BID ADDENDUM NO. 1

NEW GEORGE WYTHE HIGH SCHOOL EARLY SITE PACKAGE

RICHMOND PUBLIC SCHOOLS

May 24, 2023

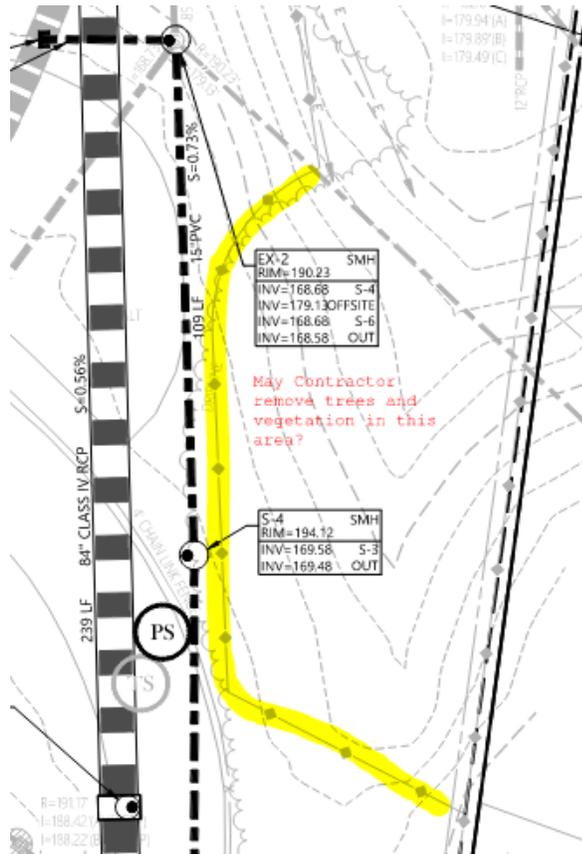
QUESTION #18: Plan sheet shows tree protection adjacent to proposed sanitary sewer MH S4. May the contractor remove these trees due to the proximity to the proposed sanitary sewer line. See below screenshot to show location and contractor proposed clearing limits.

RESPONSE: Yes, the safety fence can be shifted east to accommodate excavation, if necessary. Protection for remaining trees would still be required.
